Title: Highway 2A26 Design Speed Reduction

Memorandum (or Approval) Date: June 9th, 2014
 Design Exception Request Date: January 27th, 2014
 Region: AT North Central
 Approval Status: Approved

Project Location					
Highway	Control Section	At km	From km	To km	Existing AADT
2A	26		27.3	29.8	11,040

Diagrams

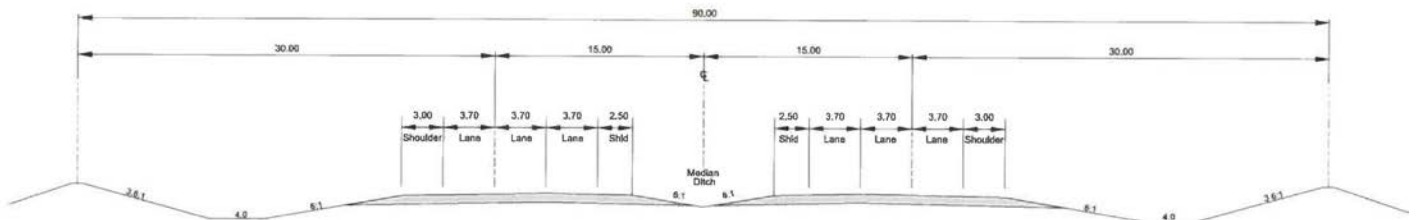
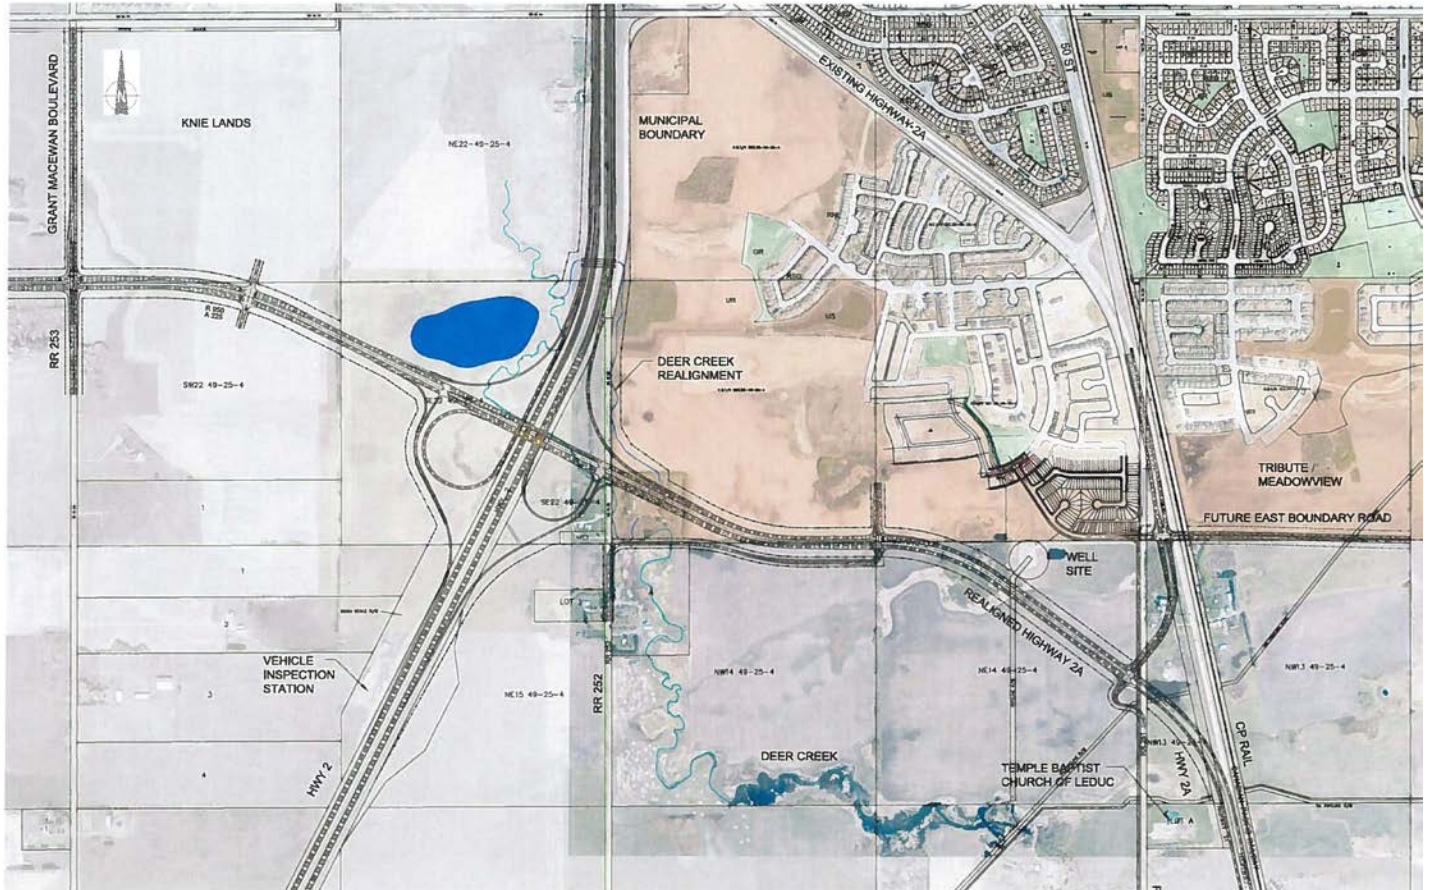
Summary
<p>In 2009, Alberta Transportation completed the Highway 2/2A Interchange Functional Planning Study which proposed to realign Highway 2A approximately 2.4km South of its current location. As part of the study, Highway 2A was given a design classification of RED-412.4-110, which is compatible with the design classification adopted for the adjacent Highway 2A Leduc to Highway 616 (Millet) Functional Planning Study. The design exception request is the reduction of design speed from 110 km/h to 90 km/h in the vicinity of the signalized intersection previously identified at the two interchange terminals, 50 street (existing Highway 2A) and the south access to South Fork.</p>

Rationale for Approval/Rejection
<ul style="list-style-type: none"> The section of roadway being considered will have four signalized intersections in close proximity operating at a posted speed of 70-80 km/h and residential development on either side. It is not appropriate to have a design speed 30-40 km/h over the posted speed, which will create unrealistic expectations from the drivers. Instead of a high-speed rural highway, the reduced design speed will make the drivers expecting a more urban environment with frequent intersections and pedestrians.
